ATTACHMENT A
EXISTING TECHNICAL SPECIFICATION
TABLE 3.3.1-1
SAN ONOFRE UNIT 2

ATTACHMENT C

SAN ONOFRE UNIT 2

**PROPOSED SAFETY ANALYSIS REPORT TEXT
SAN ONOFRE UNITS 2 & 3**

SAN ONOFRE NUCLEAR GENERATING STATION Units 2 & 3
CEA WITHDRAWAL FROM SUBCRITICAL CORE POWER vs. TIME
Figure 15.4-1

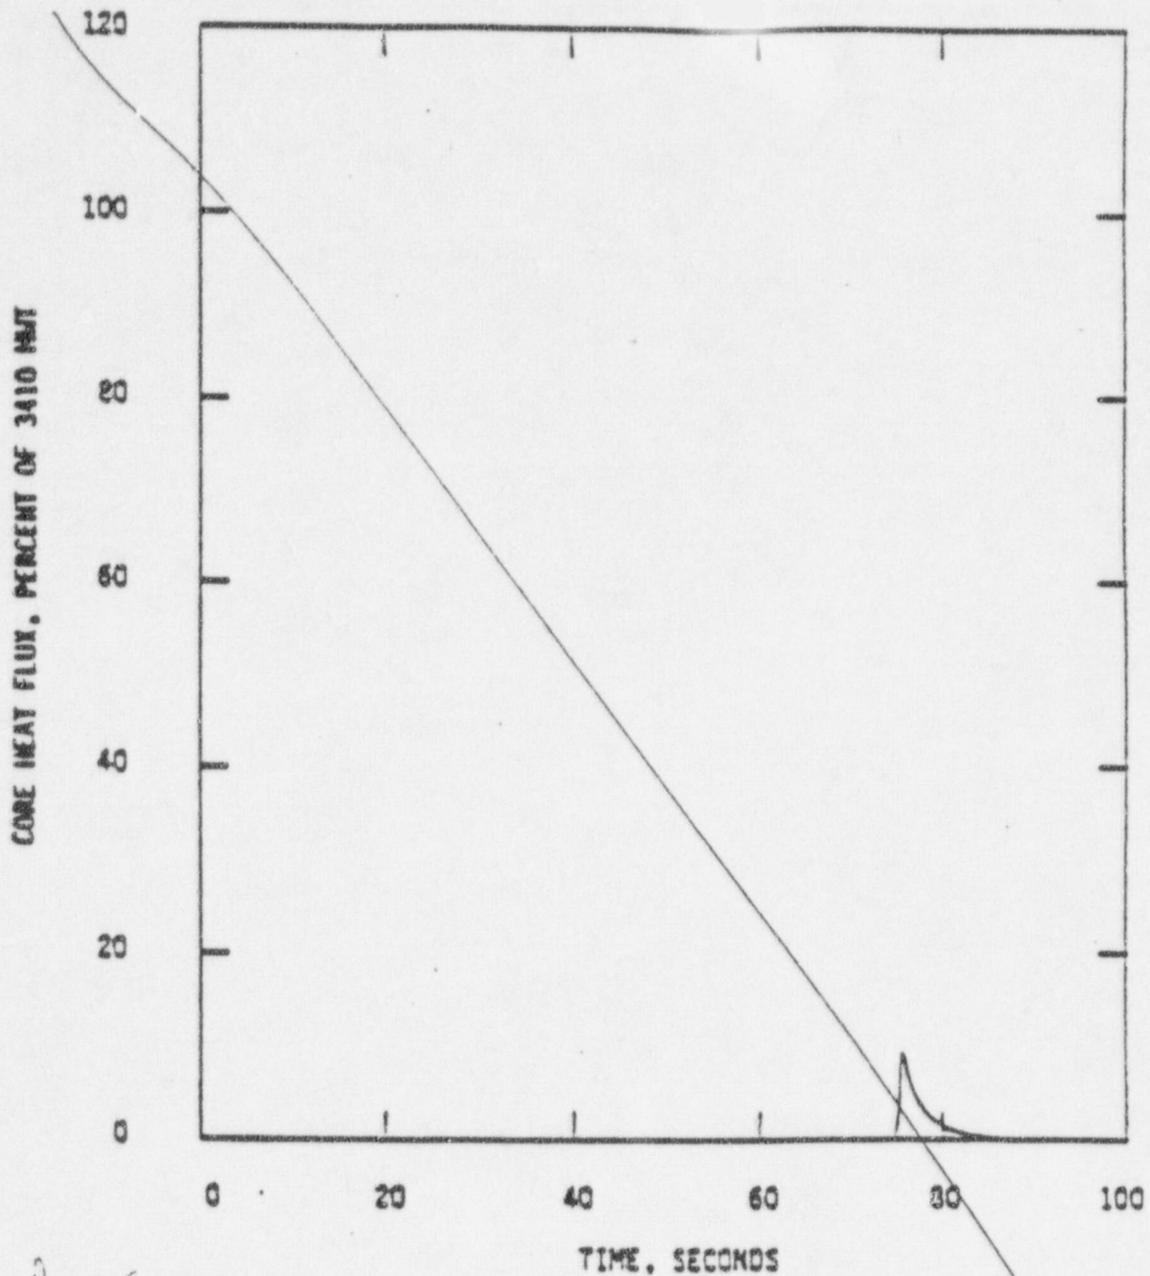
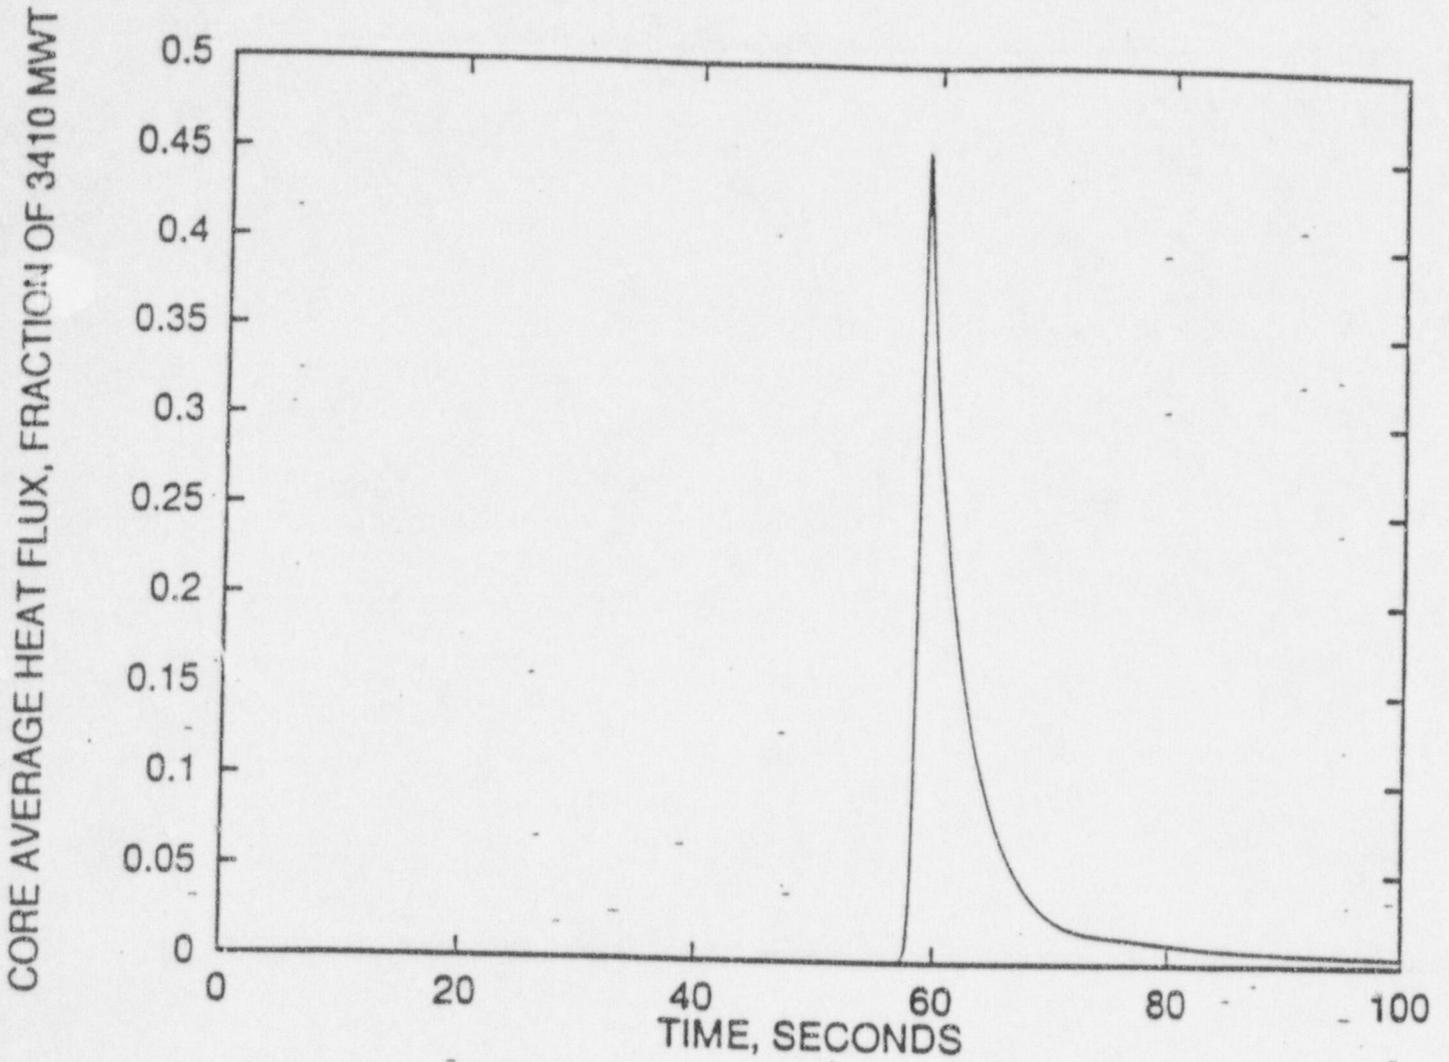
Replace

Updated

SAN ONOFRE NUCLEAR GENERATING STATION UNITS 2 & 3
CEA WITHDRAWAL FROM SUBCRITICAL POWER FRACTION vs TIME
FIGURE 15.4-1

<p>SAN ONOFRE NUCLEAR GENERATING STATION Units 2 & 3</p>
<p>CEA WITHDRAWAL FROM SUBCRITICAL CORE HEAT FLUX vs. TIME</p>
<p>Figure 15.4-2</p>

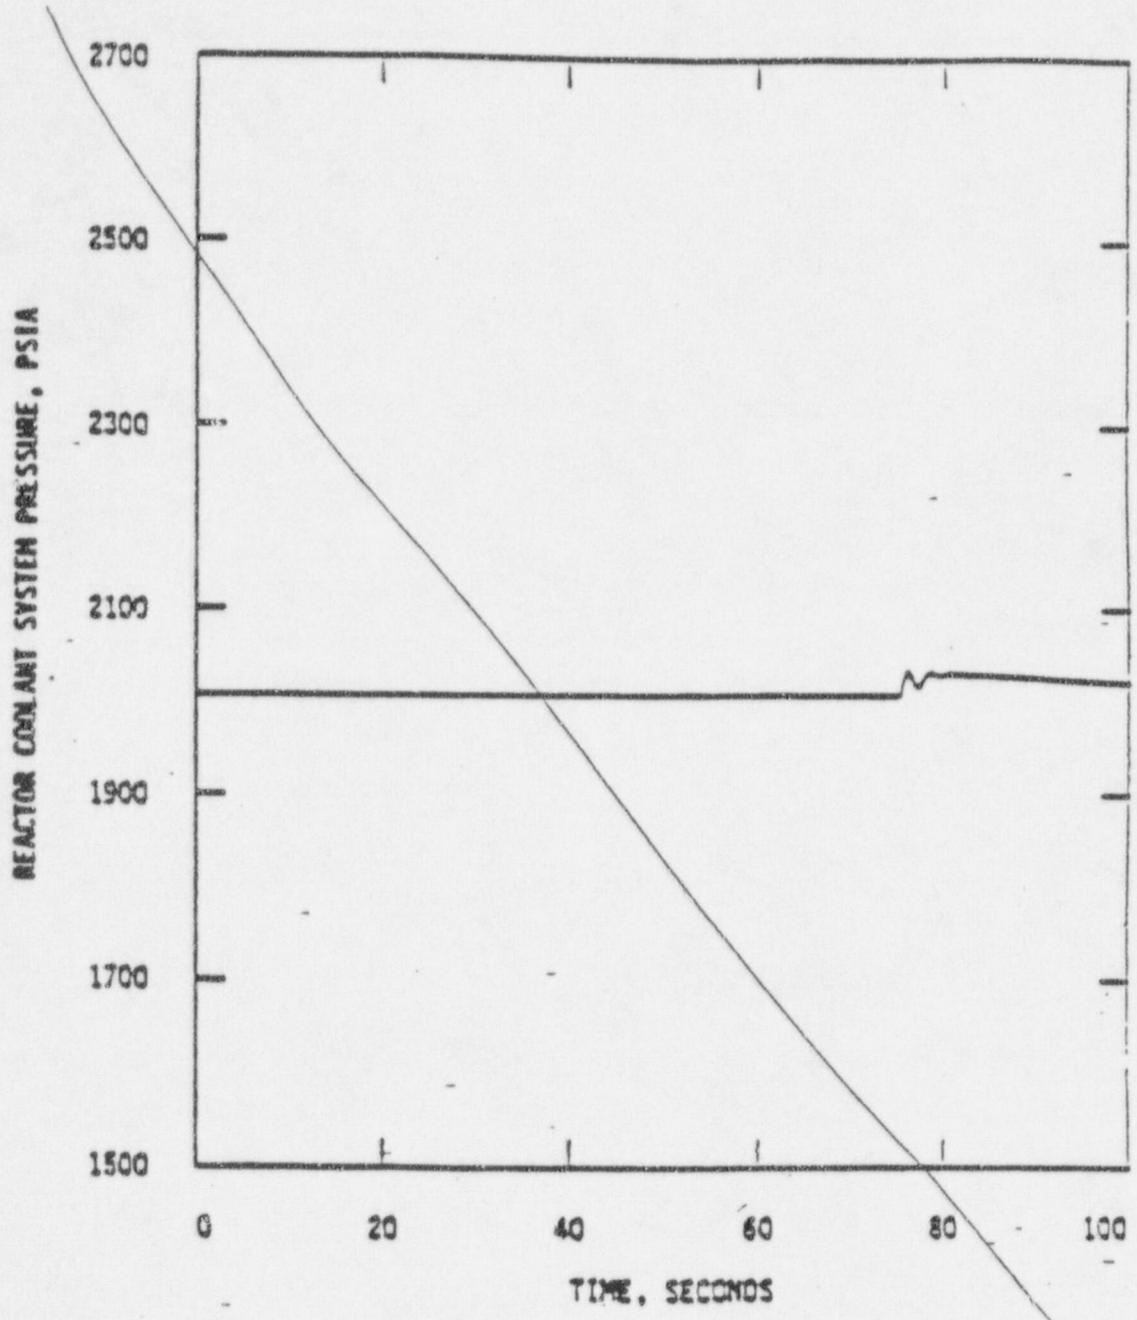
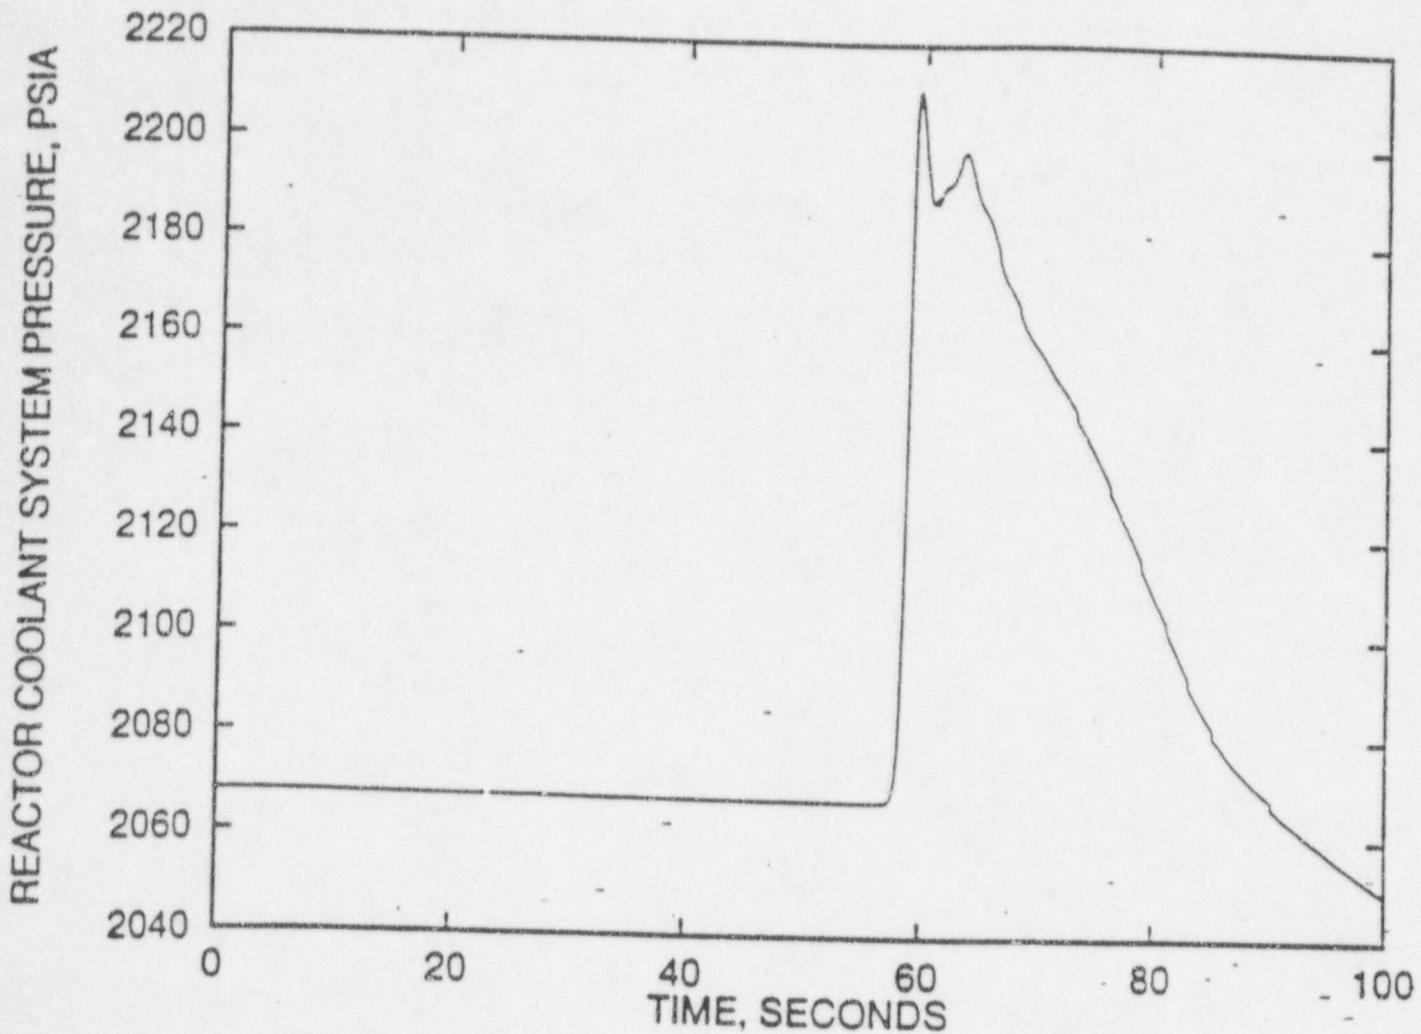
Replace

Updated

SAN ONOFRE NUCLEAR GENERATING STATION UNITS 2 & 3
CEA WITHDRAWAL FROM SUBCRITICAL HEAT FLUX FRACTION vs TIME
FIGURE 15.4-2

<p>SAN ONOFRE NUCLEAR GENERATING STATION Units 2 & 3</p>
<p>CEA WITHDRAWAL FROM SUBCRITICAL RCS PRESSURE vs. TIME</p>
<p>Figure 15.4-3</p>

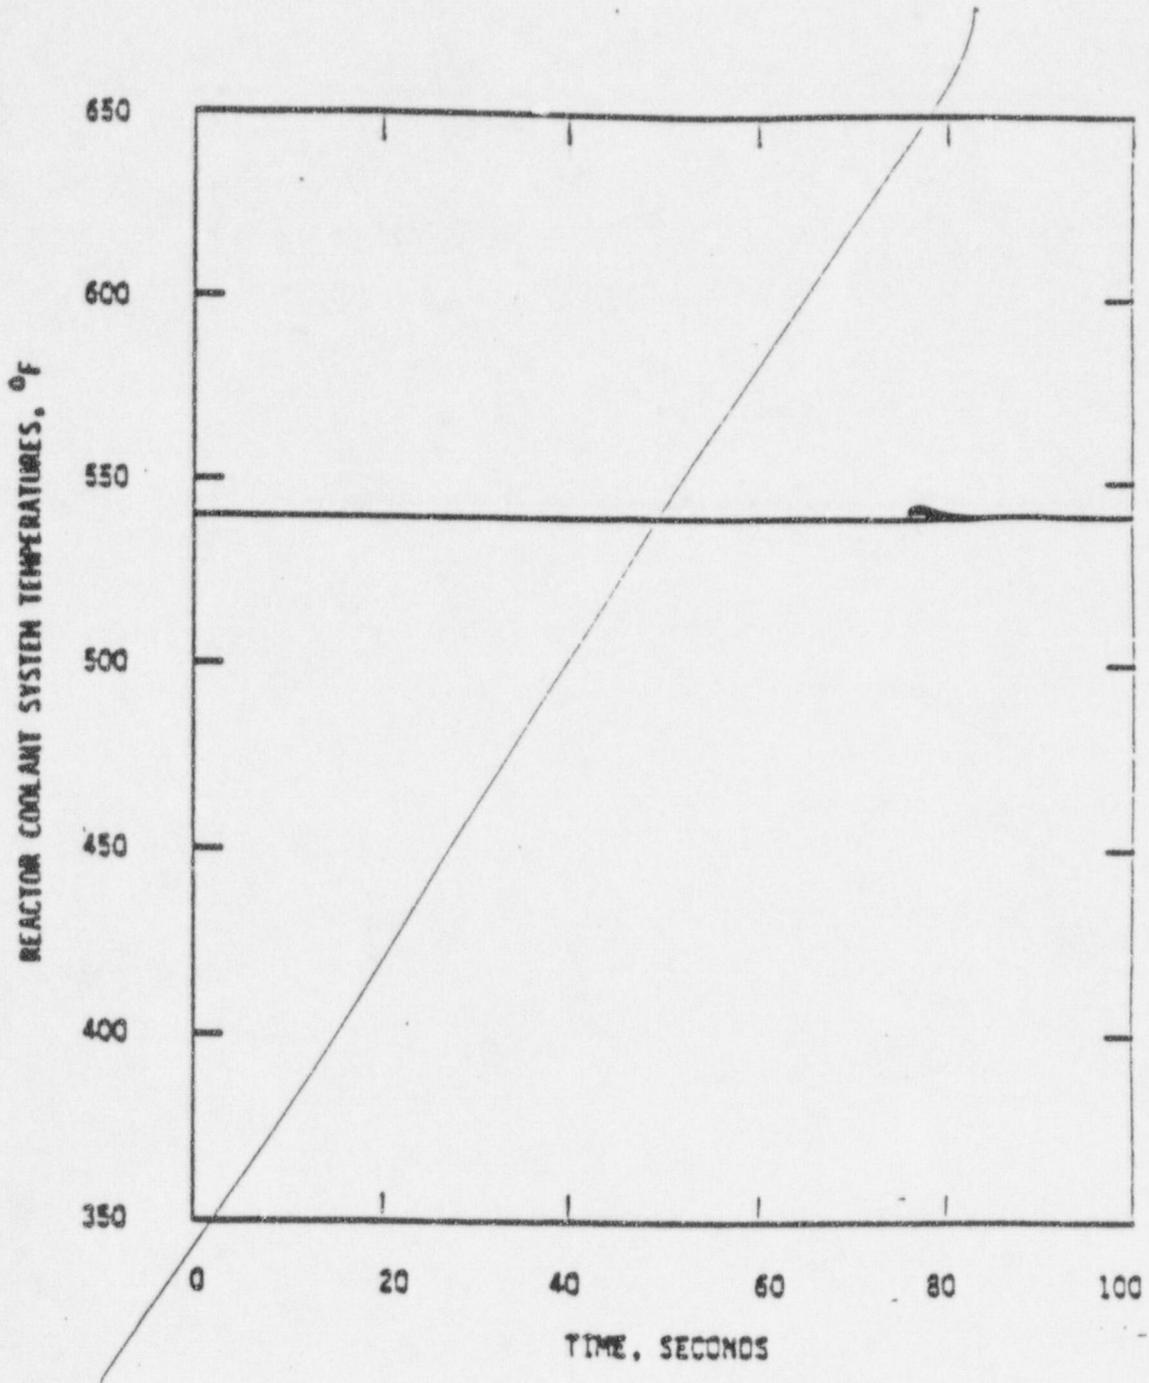
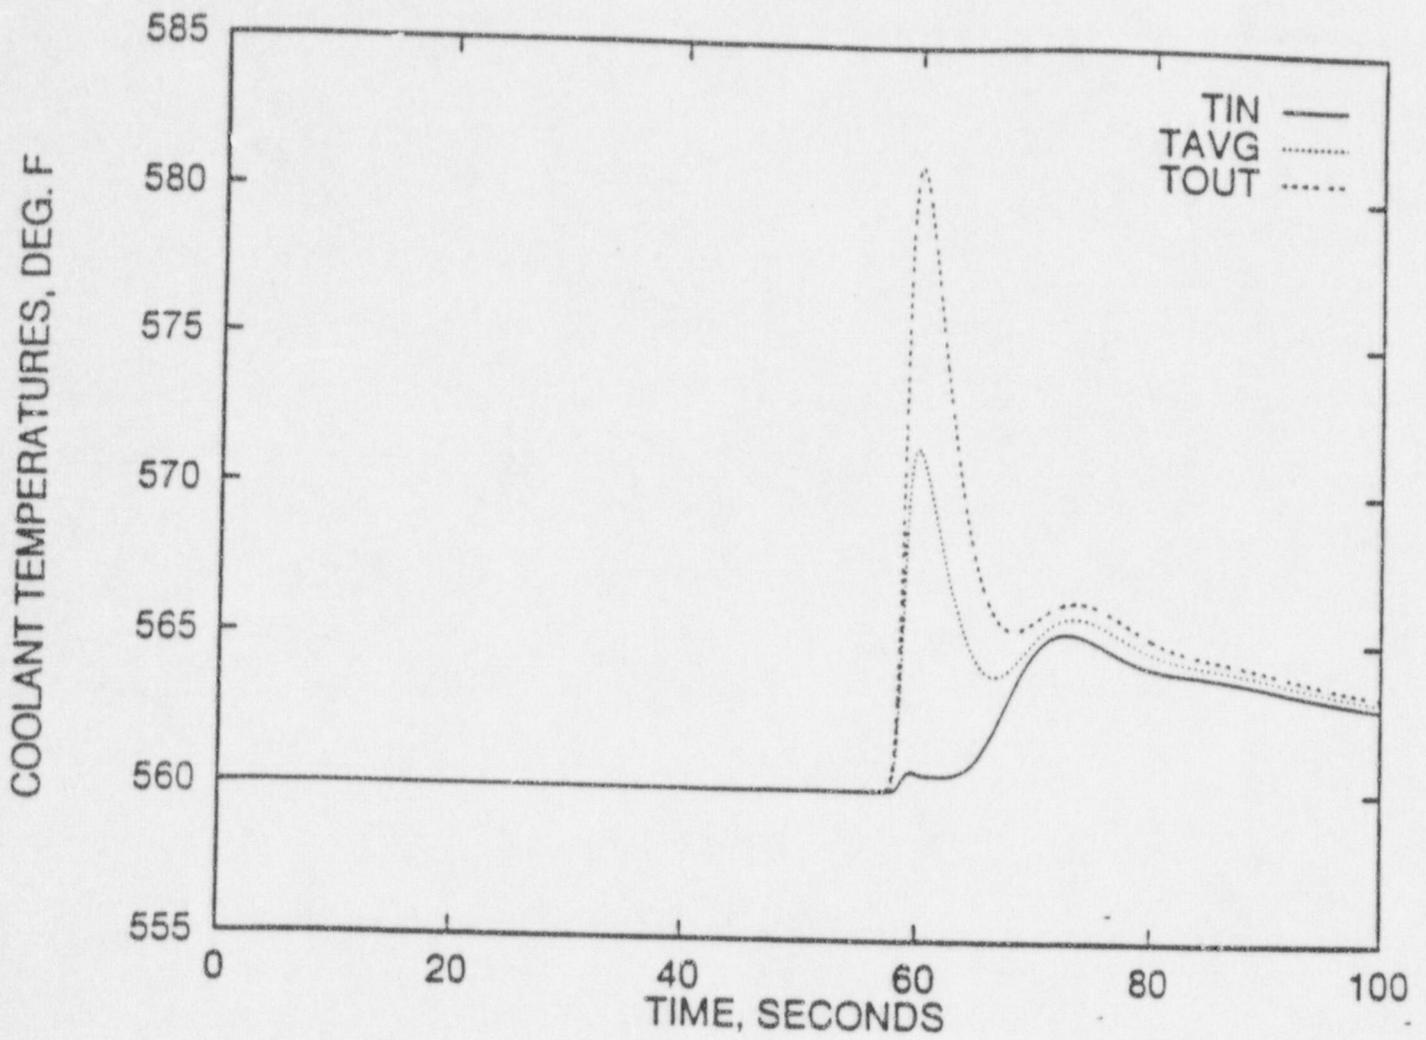
Replace

Updated

SAN ONOFRE NUCLEAR GENERATING STATION UNITS 2 & 3
CEA WITHDRAWAL FROM SUBCRITICAL RCS PRESSURE vs TIME
FIGURE 15.4-3
